NOTICE OF SPECIAL MEETING

**City Council
3800 Laverne Avenue North
Tuesday, July 22, 2014
6:00 PM**

AGENDA ITEM: Lakewood Crossing Preliminary Plat and Final Plat; Kwik Trip Conditional Use Permit

PLANNING COMMISSION
DATE: 7/14/2014
AGENDA ITEM: 4A – PUBLIC HEARING
CASE # 2014-37

SITE PLAN (LAYOUT)		
CONVENIENCE STORE #248 WITH DOUBLE BAY CARWASH		
HUDSON BLVD & KEATS AVENUE NORTH LAKE ELMO, MINNESOTA		
#	DATE	DESCRIPTION
1	06/27/14	Per City comments.
2		
3		
4		
5		
DRAWN BY		JTR/KMM
SCALE		GRAPHIC
PROJ. NO.		4982-00
DATE		2014-05-09
SHEET		SP2

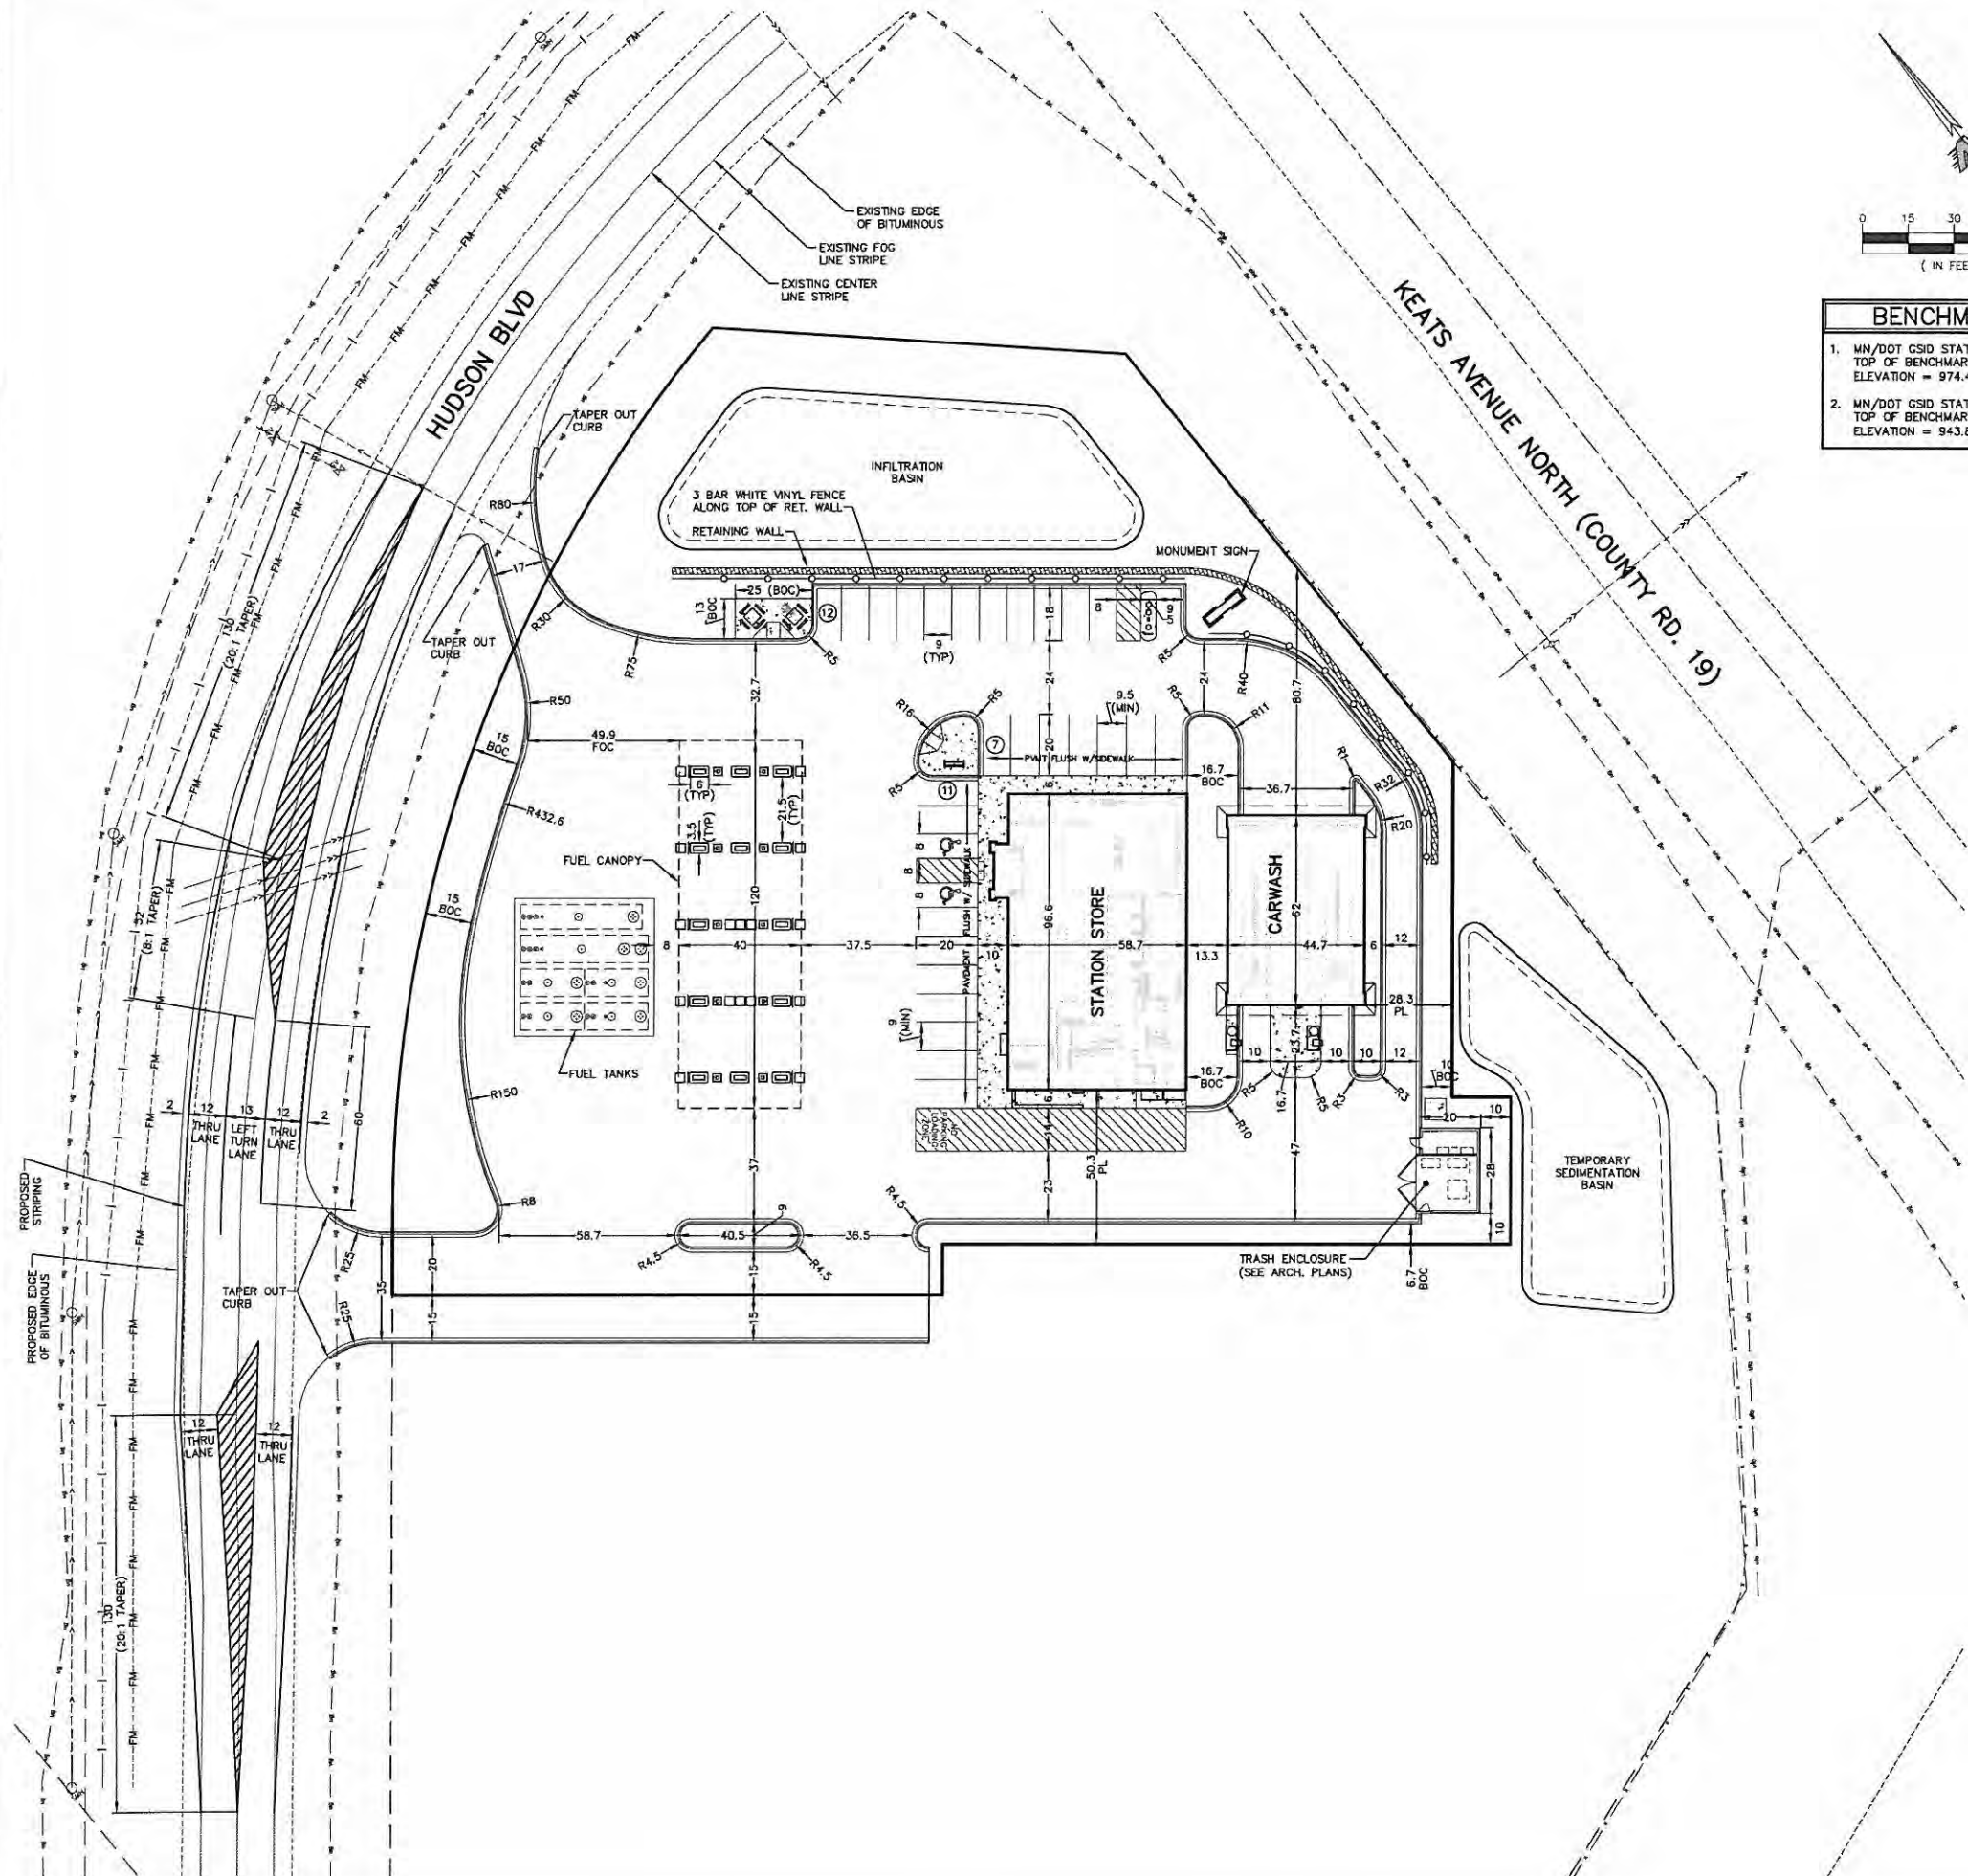
- **Access.** Staff has the following review comments related to access:
 - **Eastern Right-Out Only Access.** To provide access to the proposed gasoline station, the applicant is proposing two access locations (west and east) along Hudson Boulevard. The City Engineer reviewed the proposed access locations and found the spacing to be acceptable. However, staff is recommending that the eastern access be permitted only as a right-out only. The applicants have updated their plans to reflect this design. After reviewing the proposed right-out eastern access, staff and Washington County found that the proposed right turn is too sharp, necessitating a different design or an acceleration lane on Hudson. Staff is comfortable working with the applicant to arrive at the best suited design for the right-out eastern access (Condition #1b).

- **Left Turn Lane on Hudson Blvd.** In addition to the right-out access (eastern access), City staff also requested a left turn lane to serve the full western access of the gas station. It is important to note that Hudson Boulevard is classified as a collector road and it anticipated to serve a substantial amount of traffic as the I-94 Corridor develops. The City does not plan to expand Hudson to a 4-lane roadway. In addition, the western full access will also be designed to serve Outlot A in addition to the gasoline station. For these reasons, staff recommended a left turn lane on westbound Hudson Blvd for the full shared access between the proposed gasoline station and Outlot A. The applicants have provided the left turn lane to respond to the staff request. However, in reviewing the proposed design, the City Engineer found that the taper is too abrupt for a 50mph design speed. Staff is recommending that the taper be enlarged to allow for a more appropriate design for the existing conditions of Hudson Boulevard (Condition #1a).

- The west access should be planned for full access into and out of the site. It is proposed to be located farthest from the Hudson Boulevard/Keats Avenue intersection (~550 feet), which will limit the interaction and influence of operations between these two intersections. The width of this driveway should be at least 40 feet to accommodate one inbound lane (16 feet wide) and two outbound lanes (left-turn lane 12 feet wide and right-turn lane 12 feet wide).

- a. The design of the west-bound left turn lane proposed for the southwest access on Hudson Boulevard must be revised to incorporate a 50:1 taper to account for the 50mph design speed of the road as suggested by the City Engineer and the supporting consultant.

- b. The design of the northeast right-out only access must be revised per the recommendation of the City Engineer and Washington County. The design of the northeast access must be approved by the City prior to the approval of the building permit.

- c. The width of the western full access road must be modified to 40 feet to allow for one inbound lane (16 feet wide) and two outbound lanes (left and right turn lanes, 12 feet wide).

GRADING & EROSION CONTROL	
CONVENIENCE STORE #248 WITH DOUBLE BAY CARWASH	
HUDSON BLVD & KEATS AVENUE NORTH LAKE ELMO, MINNESOTA	
#	DATE DESCRIPTION
	06/27/14 Per City comments.
DRAWN BY JTR/KMM	
SCALE GRAPHIC	
PROJ. NO. 4982-00	
DATE 2014-05-09	
SHEET	
SP3

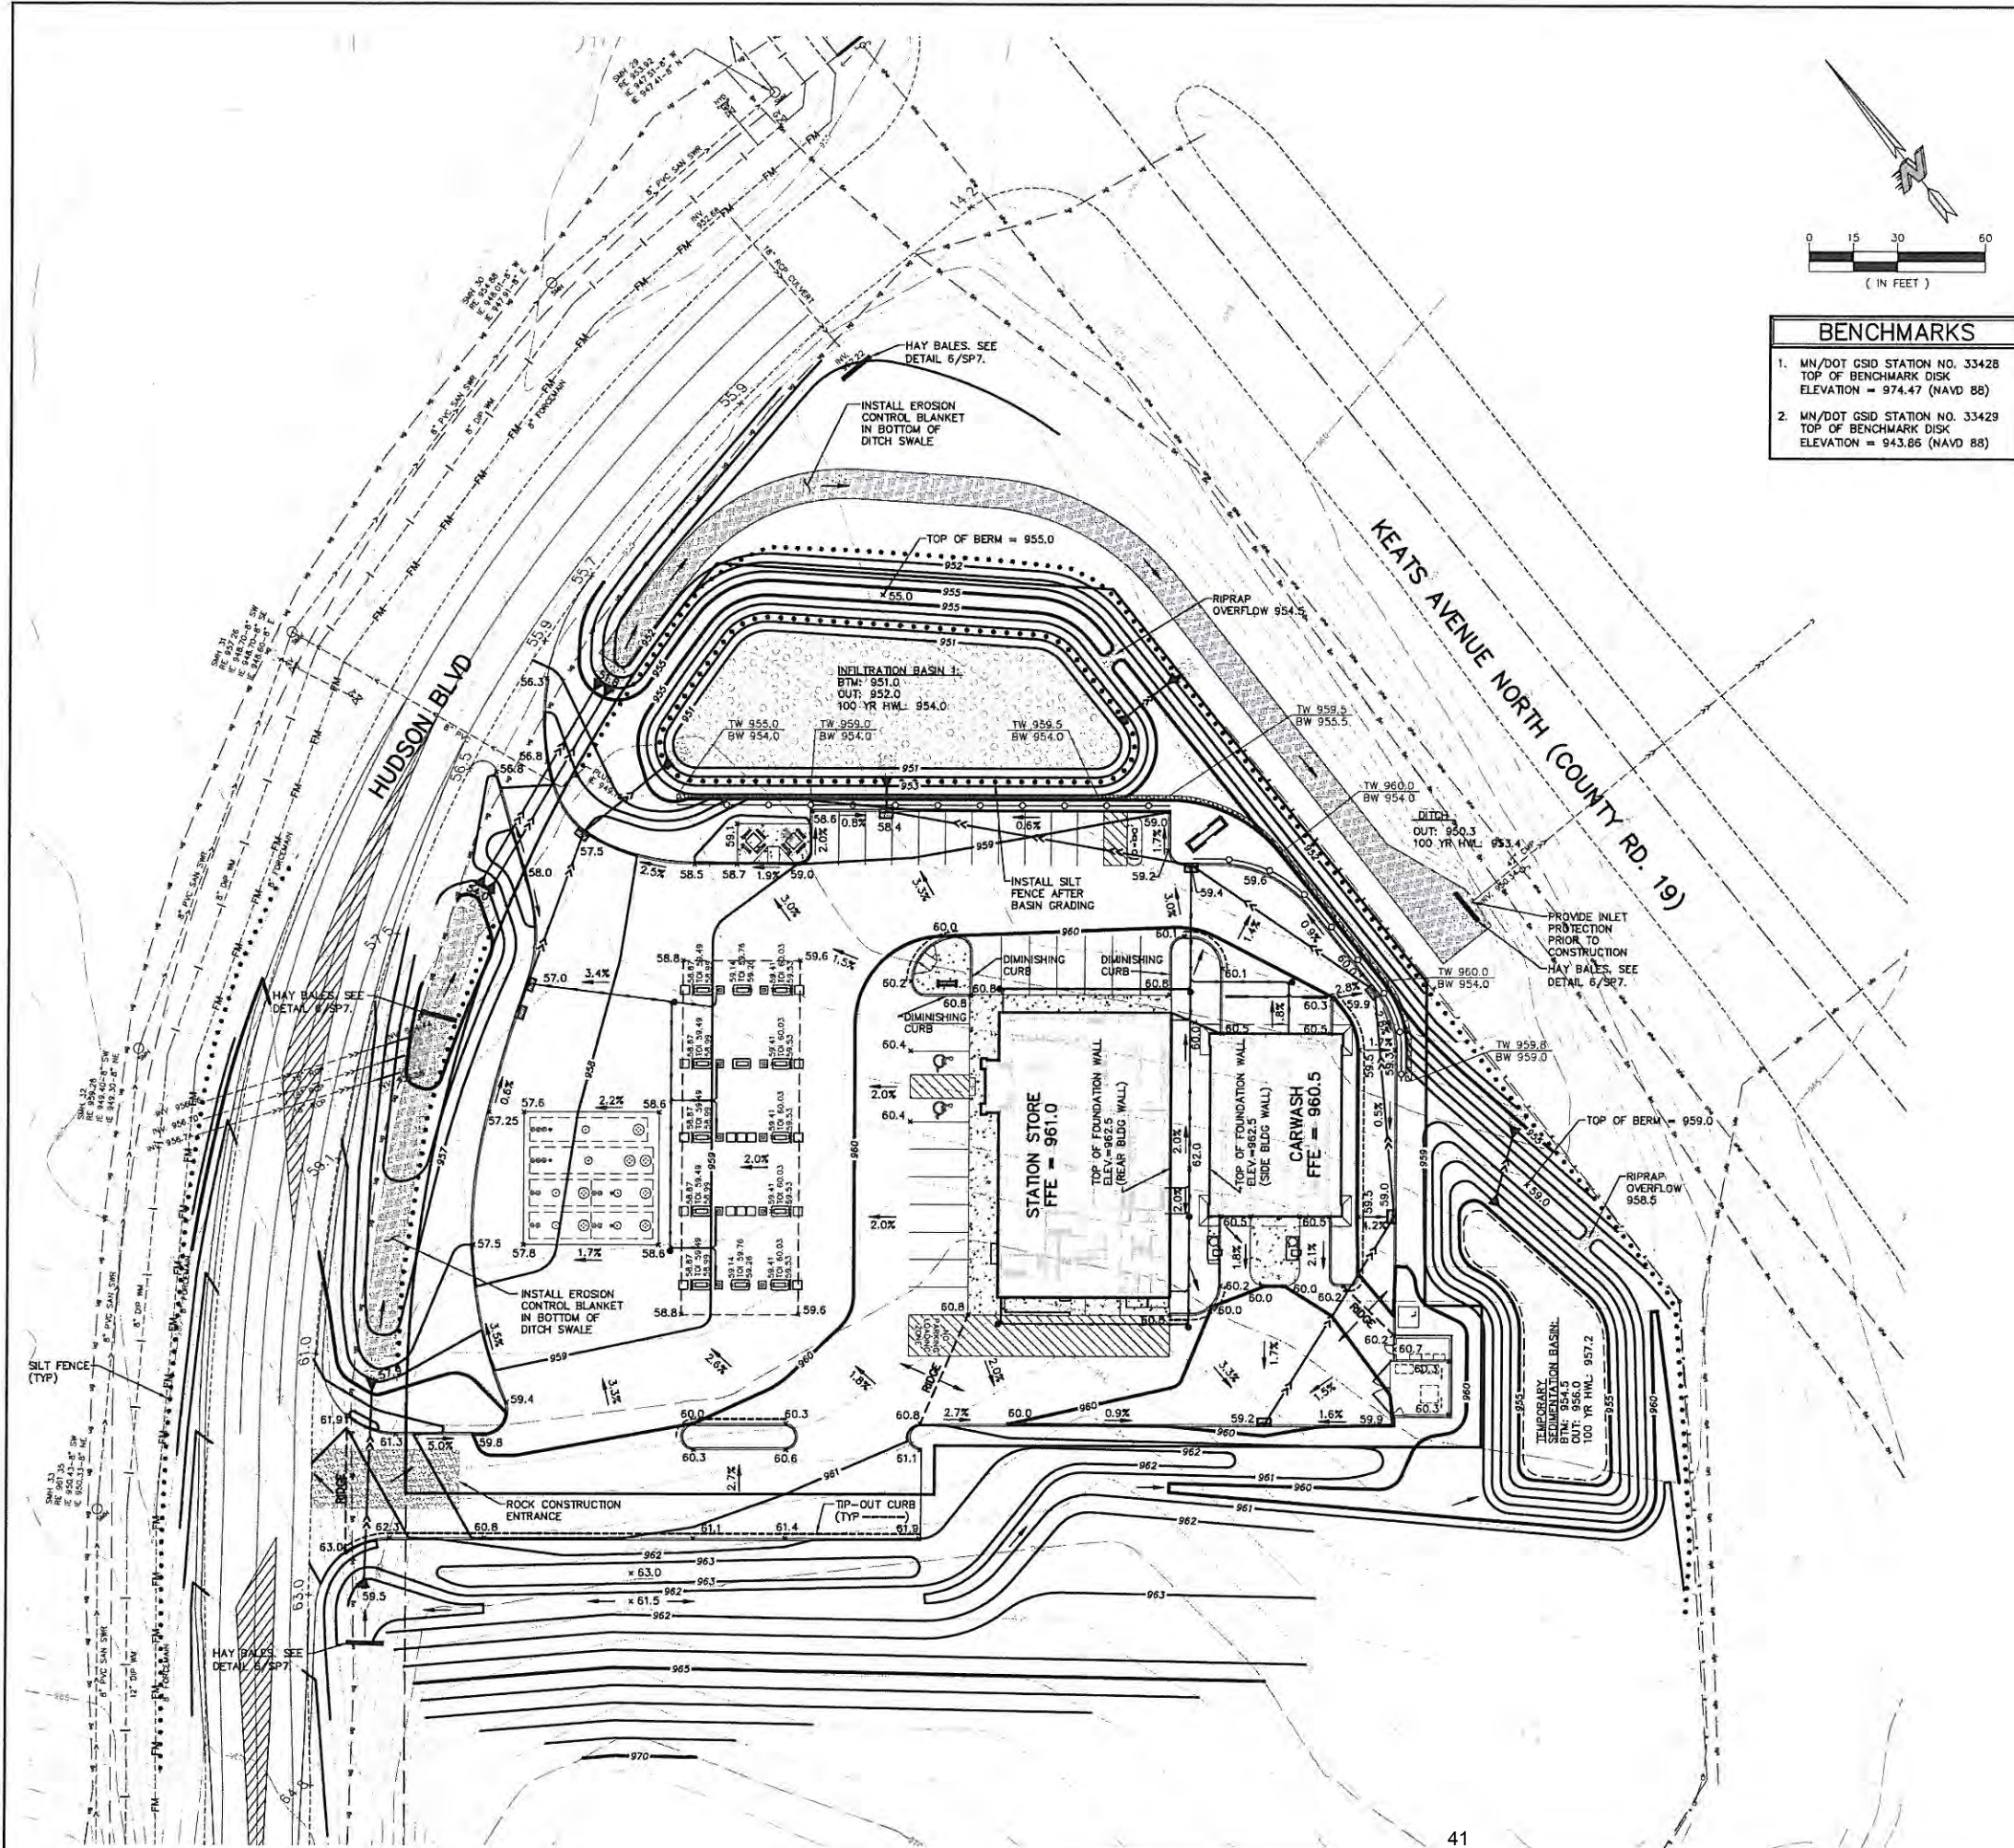
1. The drainage and utility easements must be placed on both the utility plan, Sheet SP4, and the grading plan, Sheet SP3 to demonstrate sufficient easement is being provided. A minimum 15 feet of utility easement is required from the centerline of the proposed watermain utility. It appears additional easement is required.

1. City Standard Plan Notes for Grading and Erosion Control, Details 600A-D, must be placed on the Grading and Erosion Control Plan, Sheet SP3. All other conflicting information must be removed. Supplemental notes may be provided if not already addressed by the City standards.
2. Governing Specifications for grading and erosion control must be in accordance with the City of Lake Elmo standard specifications.
3. Retaining walls that exceed 4 feet in height must have a design submitted and certified by an engineer licensed in the state of Minnesota.

UTILITY PLAN
CONVENIENCE STORE #248
WITH DOUBLE BAY CARWASH
HUDSON BLVD & KEATS AVENUE NORTH
LAKE ELMO, MINNESOTA

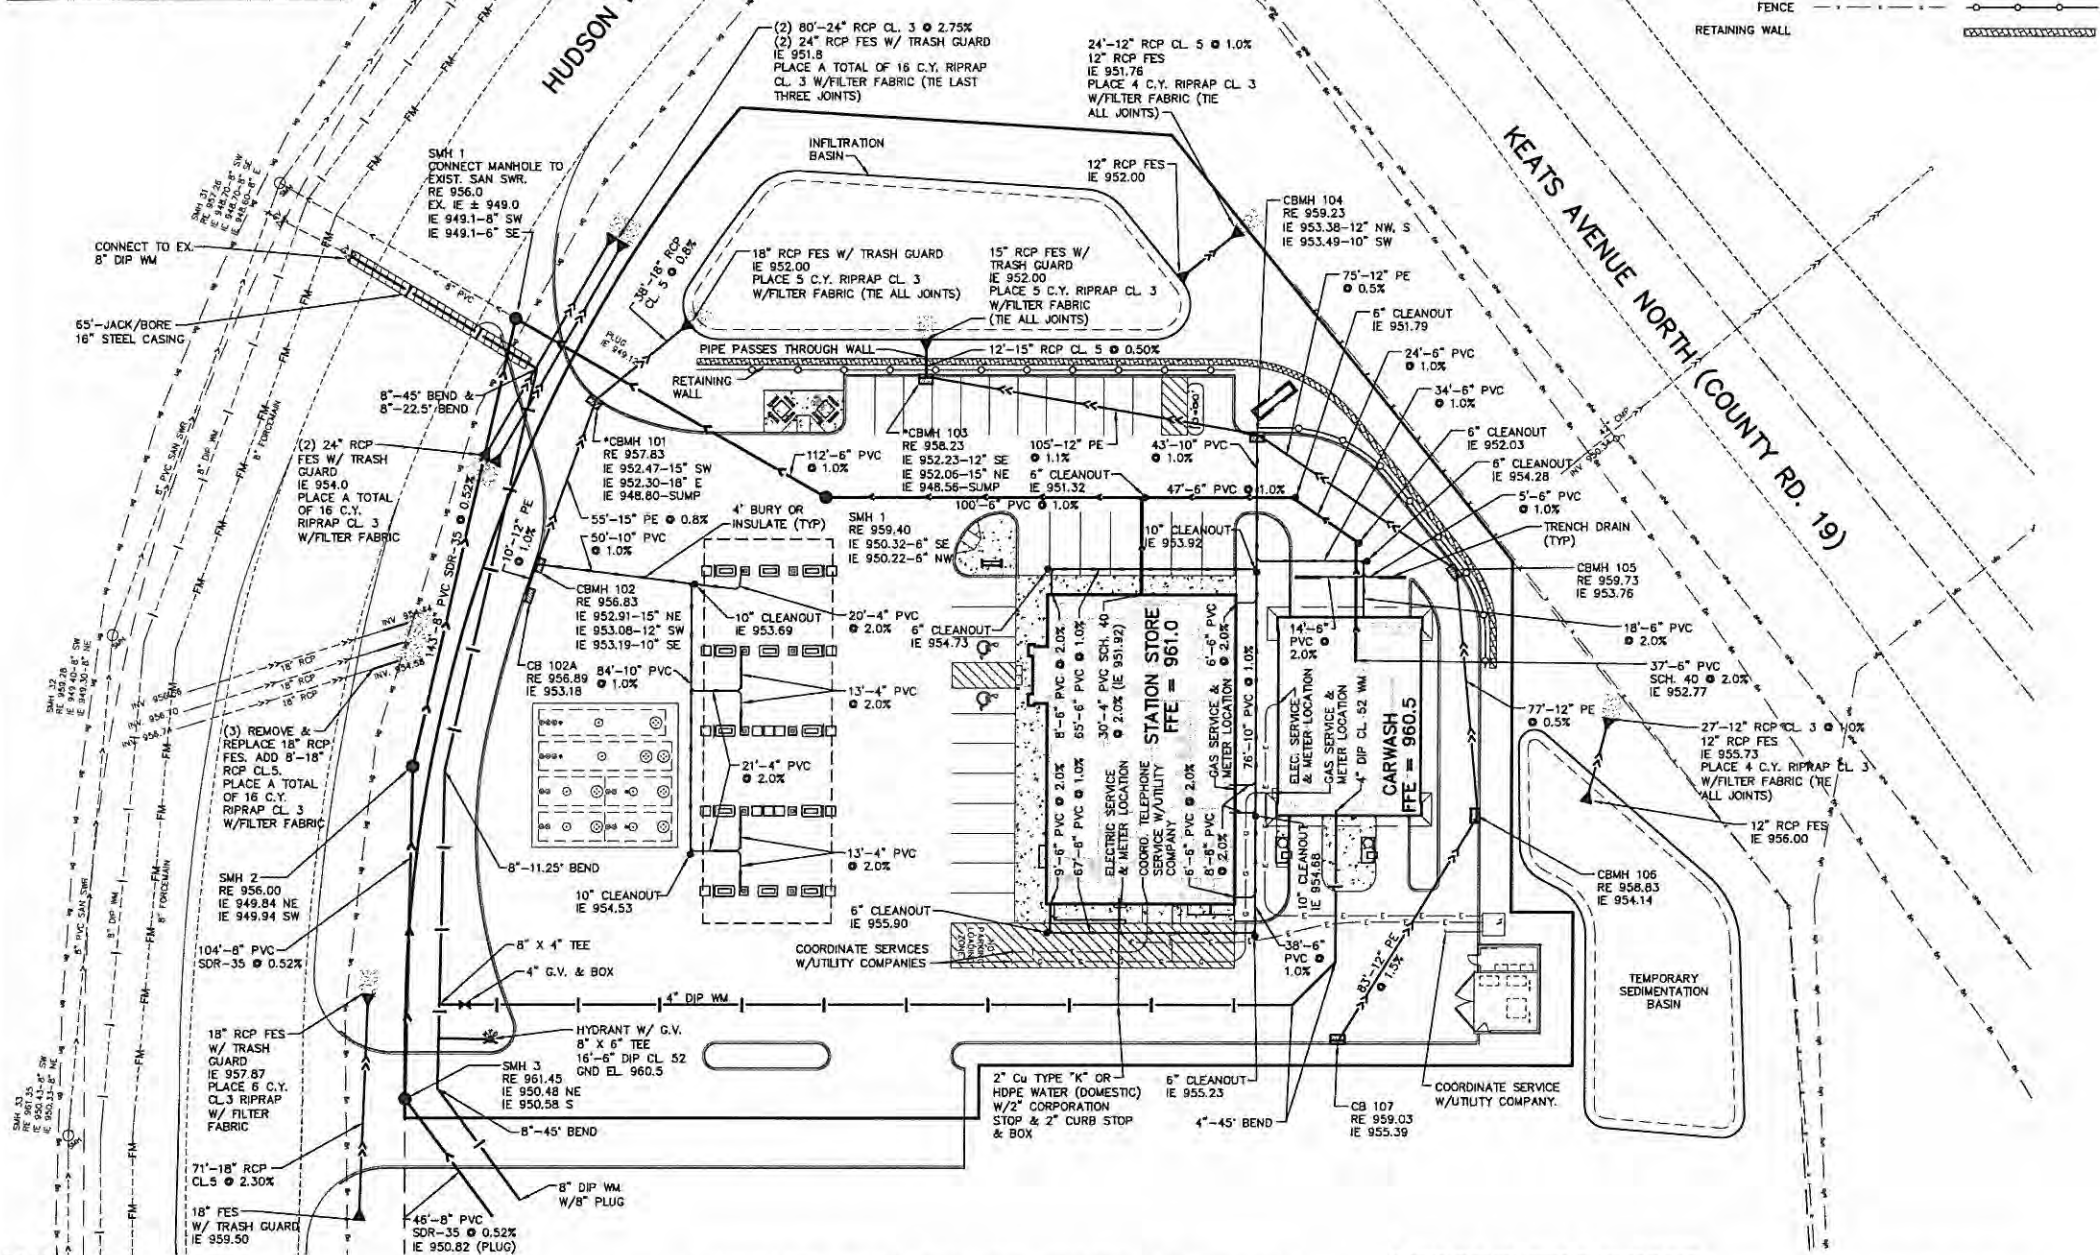
1. City Standard Plan Notes for Watermain, Detail 200A, for Sanitary Sewer, Detail 300A, and for Storm Sewer, Detail 400A, must be placed on the Utility Plan, Sheet SP4. All other conflicting information must be removed. Supplemental notes may be provided if not already addressed by the City standards.
